ELGIN
VACTOR
GUZZLER
JETSTREAM
RAVO

Subject: Elgin Sweeper CNG Broom Bear Sweepers on Sterling Actera Chassis

SERVICE BULLETIN

SUBJECT: SAFETY RECALL
 Exhaust Re-Route Broom Bear CNG Sweepers
 mounted on Actera Chassis.

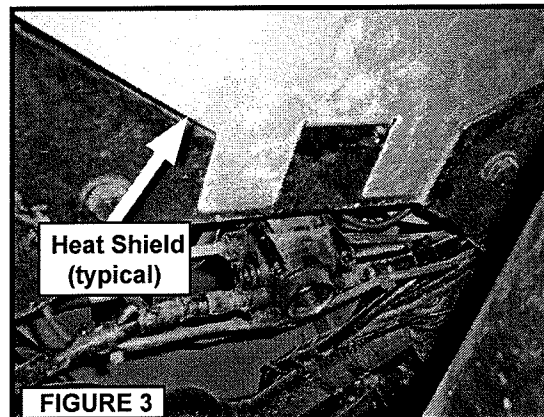
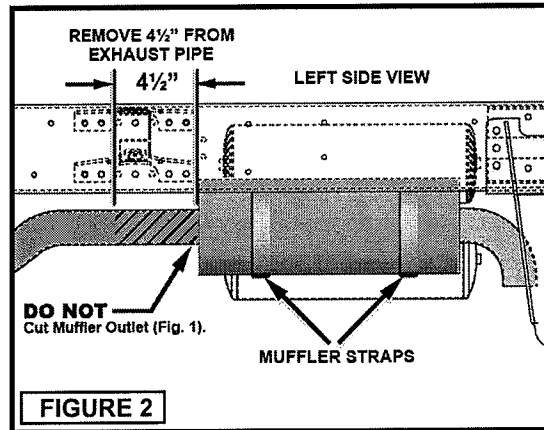
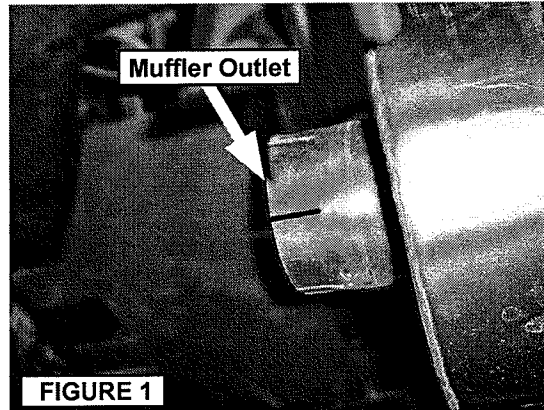
Accumulated debris either packed into the exhaust pipe or trapped in front of the elevator assembly could ignite due to high CNG exhaust temperatures while sweeping. The exhaust

The design of the exhaust outlet is not routed adequately to discharge high CNG exhaust temperatures away from any potential accumulating debris.

- Remove hydraulic valve cover.
- Remove tailpipe from muffler outlet (Fig. 1&6).
- Resize muffler outlet connection using a suitable expander or other tool (Fig. 1).
- Loosen muffler straps and exhaust pipe clamp.
- Slide muffler rearward.
- Cut 4-1/2" from end of exhaust pipe (Fig. 2).
- Re-install muffler and tighten straps.
- Install heat shield to the chassis cross member as shown using hardware supplied in the kit.

NOTE: It may be easier to remove Intermediate exhaust pipe to cut the pipe.
NOTE: There are two types of chassis cross members. Fig. 3 is a direct bolt-in to existing holes. Others (not shown) must be drilled for hardware.
